No. 614A

April 14, 1971

Replaces No. 614

## 1971 ELECTRA GLIDE / SUPER GLIDE

FIGURE NO. 1

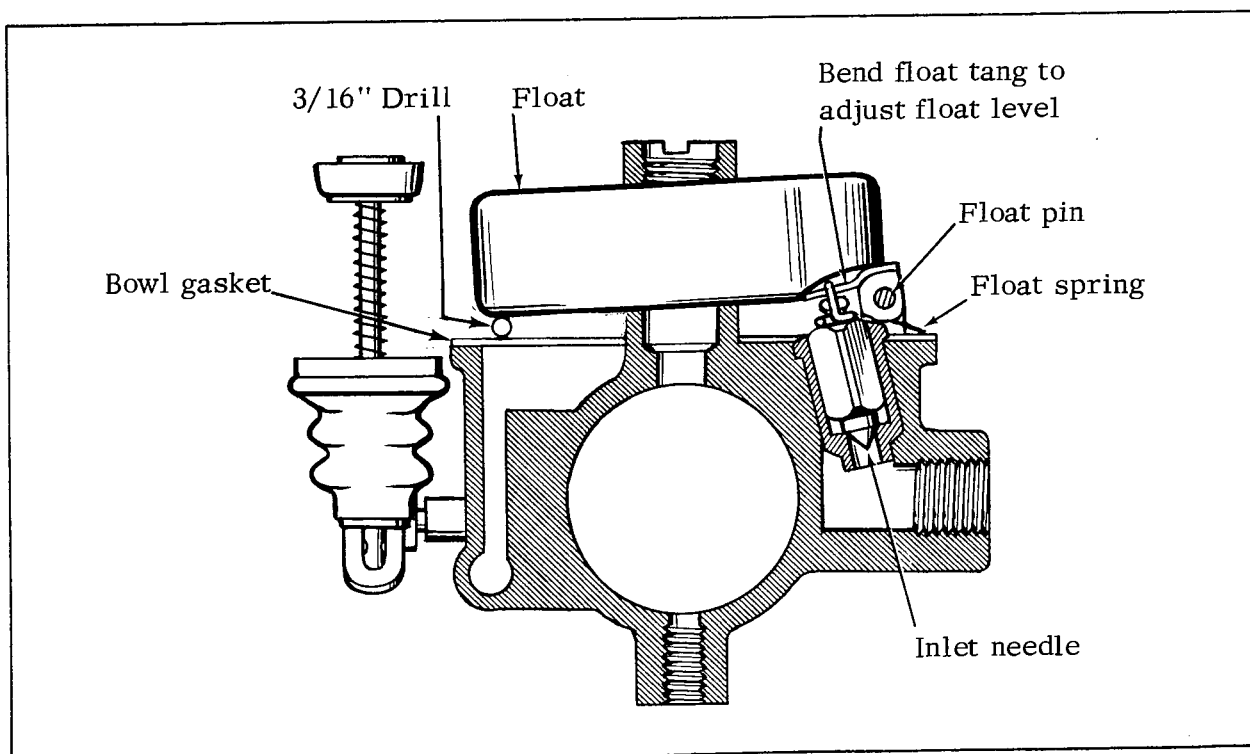
Float setting changed from 1/8 in. to 3/16 in. to remedy a rich condition occurring at steady speeds. To correct, remove bowl nut and bowl. Hold carburetor upside down and measure height of float above surface of gasket with a 3/16 in. dia. drill as shown in diagram below. To raise float (results in lower fuel level), bend brass tang downward toward needle. To lower float, bend tang up. See Figure 1 following.

FIGURE NO. 2

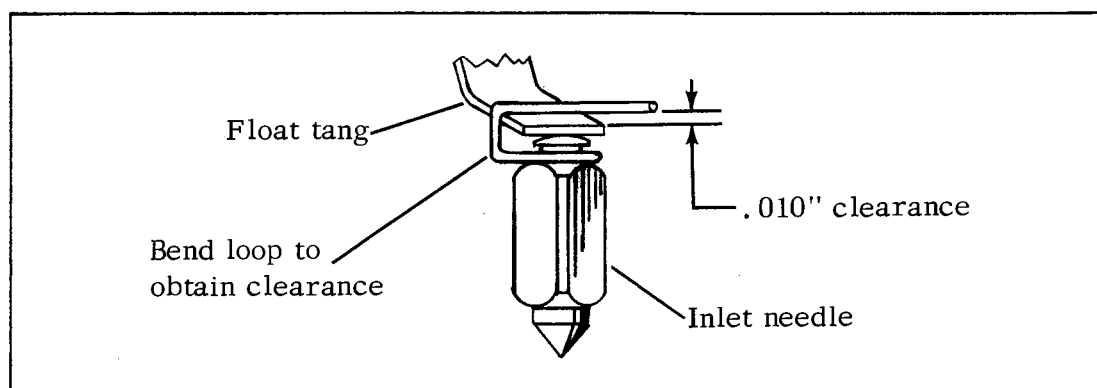
Clearance between float tang and inlet needle wire clip decreased-should be .005 to .010 in. To correct, close up loop of wire by bending with a pliers as shown in Figure 2 following. Needle should operate freely with no bind when carburetor is held upright and float moved up and down.

Later carburetors have a bend in the upper leg of the loop.

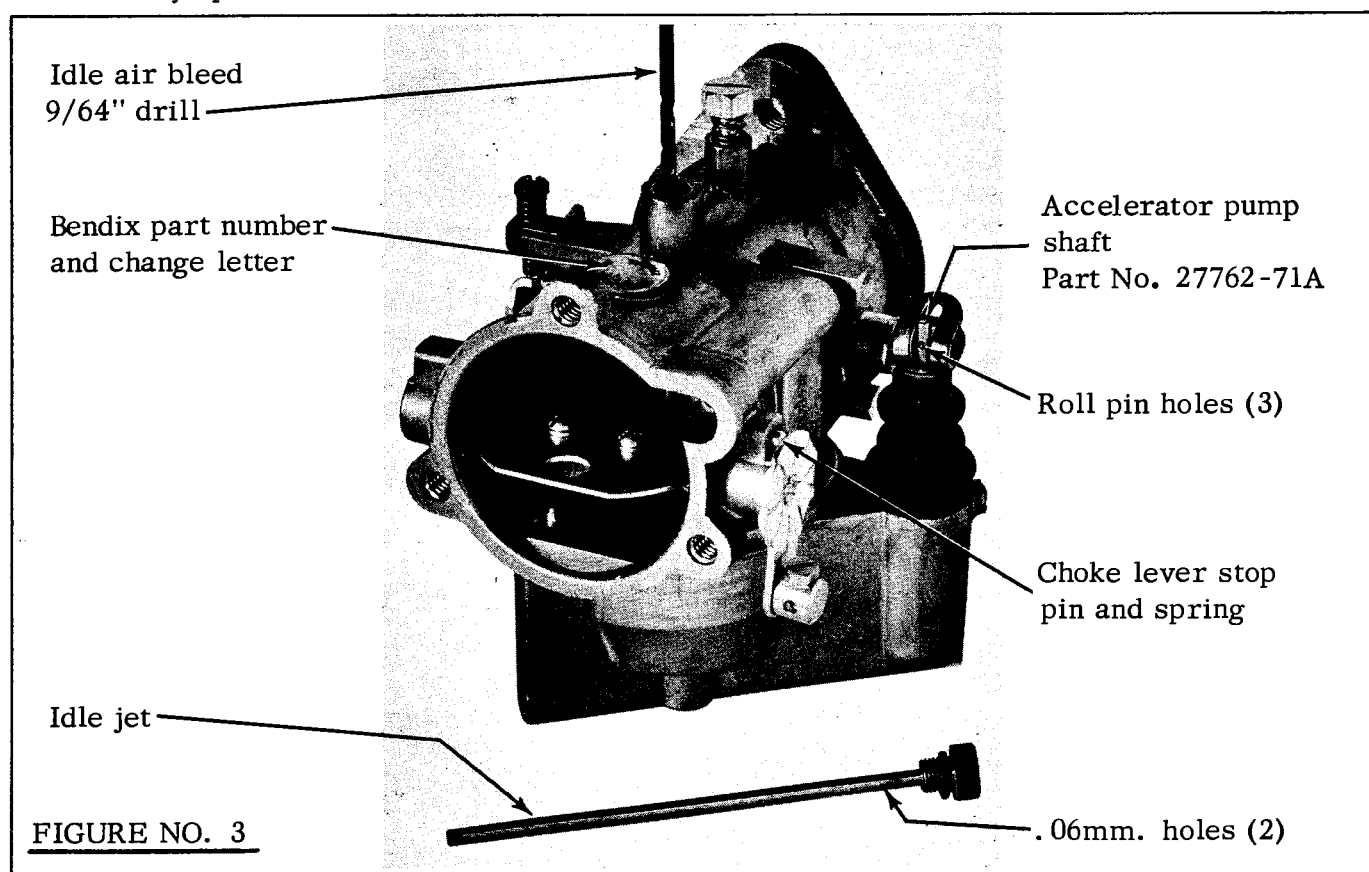
New carburetor choke shaft has detents with a spring loaded plunger engaging the detents to provide positive positioning throughout the choking range (See Figure 3).

New Part No. 27664-71 Choke shaft replaces 27664-70

New Part No. 27665-71 Plunger added

New Part No. 27666-71 Plunger spring added

New idle jet with two .06 MM holes instead of one .08 hole near screw end. New part No. 27725-71 idle jet is identified by letter A stamped on screw end and it replaces part No. 27723-71.

FIGURE NO. 4

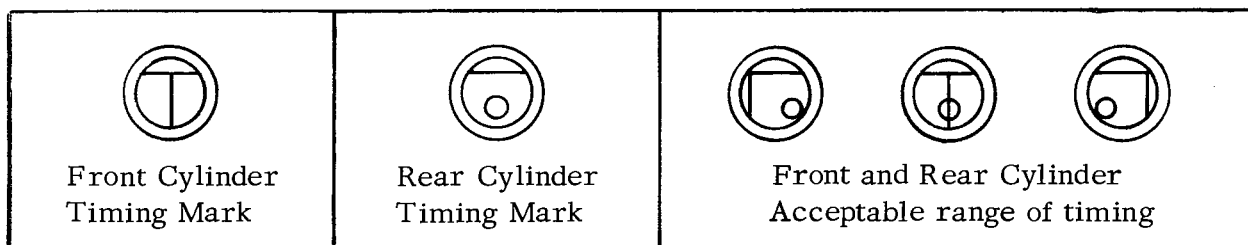
Starting with the 1971 models, a rear cylinder ignition timing mark, a 1/4 in. dia. drill point hole, has been added to the flywheel so that both front and rear cylinder advanced ignition timing can be checked with a strobe timing light. With engine running at 2000 R.P.M., the front cylinder timing mark line should appear in the center of the hole with the rear cylinder timing mark dot appearing on or near the line. (See diagrams below.)

If both timing marks cannot be brought into view in crankcase inspection hole by shifting the circuit breaker base clockwise or counter-clockwise, check circuit breaker point gap to see that it is within .018 to .020 in. on highest point of both cam holes.

Correct any cause for eccentric cam operation so that point gaps will be within limits and then adjust breaker base to bring both timing marks into inspection hole with strobe timing light at 2000 R. P. M.

FIGURE NO. 5

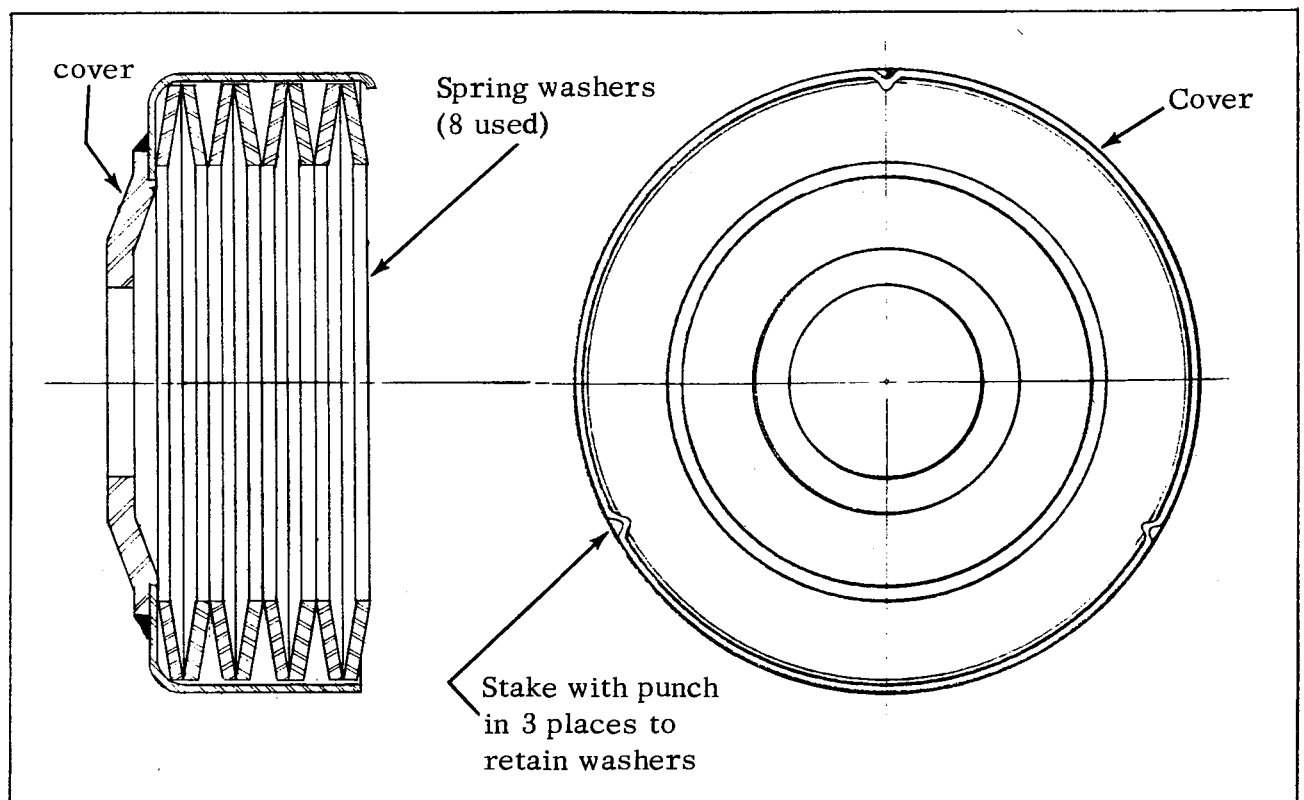
The compensating sprocket spring cover thickness has been increased from .040 to .060 to strengthen against deforming. It is recommended that you install a new heavier cover, part No. 40385-70 on all motorcycles below VIN - 26758 H1. On very early production models also install new spring cup, part No. 40324-70 which is .840 in. high and replaces early spring cup which was .900 in. high. Compensating sprocket noise is an indication of loss of preload on the spring washers.

To remove and install parts, remove primary cover, compensating sprocket nut and spring assembly. To remove springs from cover, bend staking open in 3 places with a vise grips so that 8 dished spring washers can be removed. Inspect washers and if damaged, replace with new ones, or replace entire assembly part No. 40324-70. Before installing 8 washers in new heavier cover, remove sharp edges from outside diameter with emery cloth. Install washers in the cover exactly as shown in following figure and stake cover in 3 places as shown.
